Well Name: SILVER FED COM	Well Location: T20S / R33E / SEC 16 / TR A / 32.580084 / -103.661568	County or Parish/State: LEA / NM
Well Number: 114H	Type of Well: OIL WELL	Allottee or Tribe Name:
Lease Number: NMNM094851	Unit or CA Name:	Unit or CA Number:
US Well Number: 3002551289	Well Status:	Operator: MATADOR PRODUCTION COMPANY

Sundry ID: 2775290

Type of Submission: Notice of Intent	Type of Action: APD Change
Date Sundry Submitted: 02/15/2024	Time Sundry Submitted: 12:35
Date proposed operation will begin: 02/15/2024

**Silver #114H API 30-025-51289 – Remediation Procedure**

**Silver #114H API 30-025-51289: Remediation – Actual Results**

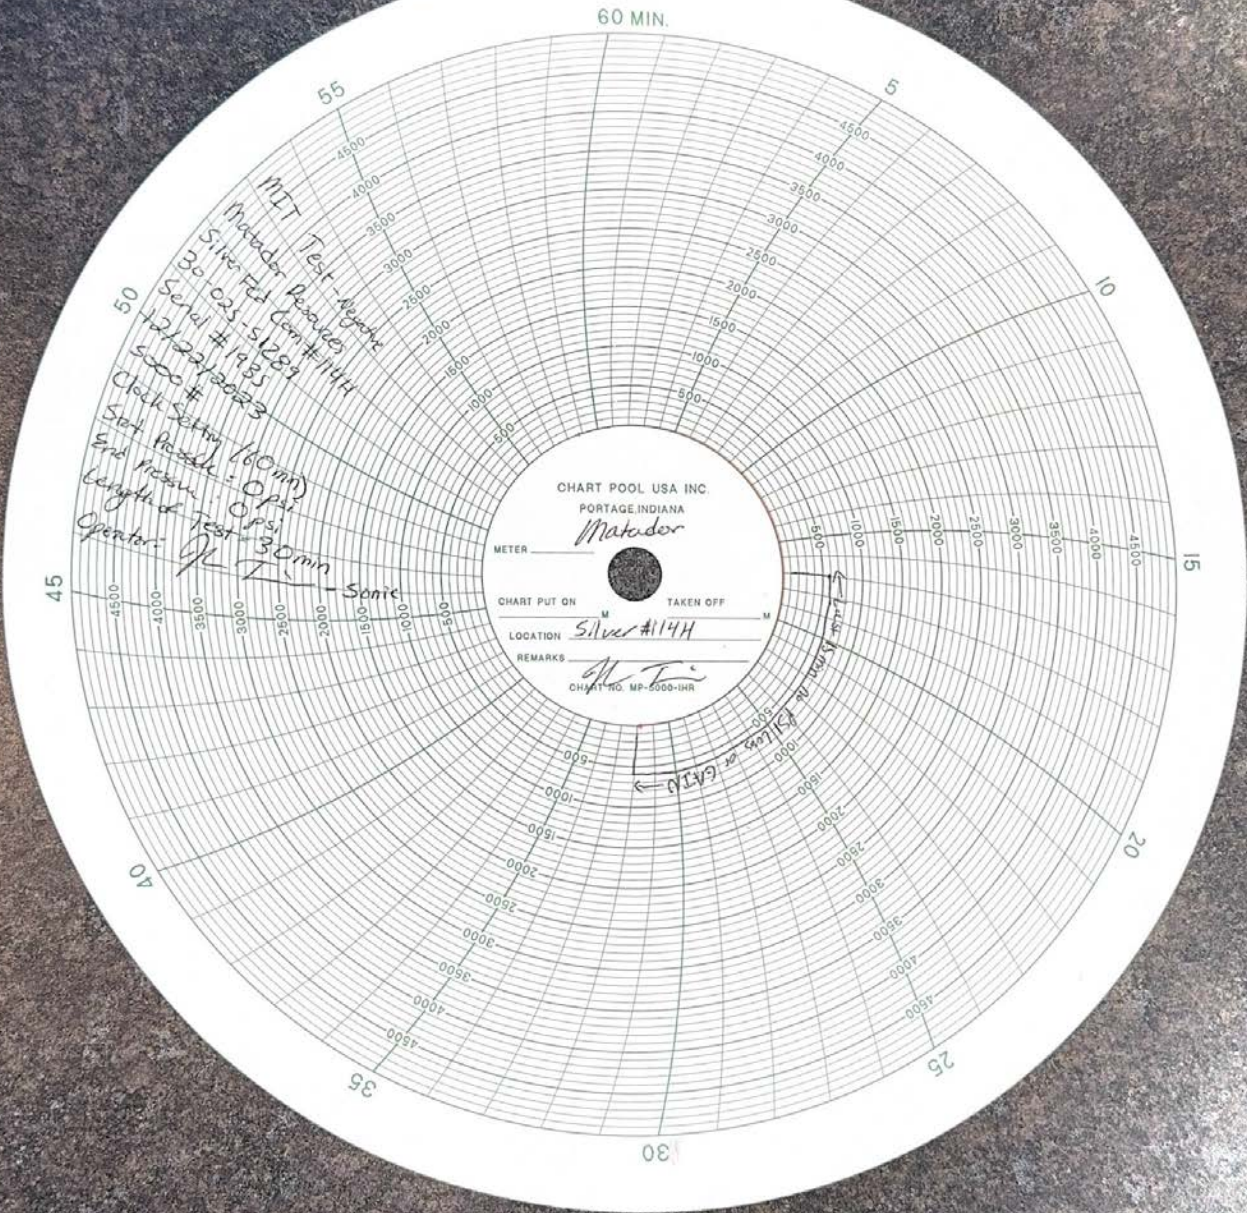
Heel Hardline: 9,615' MD

Lease Line Intersection: 9,514' MD

**New First Take Point: 9,673' MD**

New First Take Point: 9,673' MD (58' MD inside Heel Hardline and 159' MD inside Lease Line)
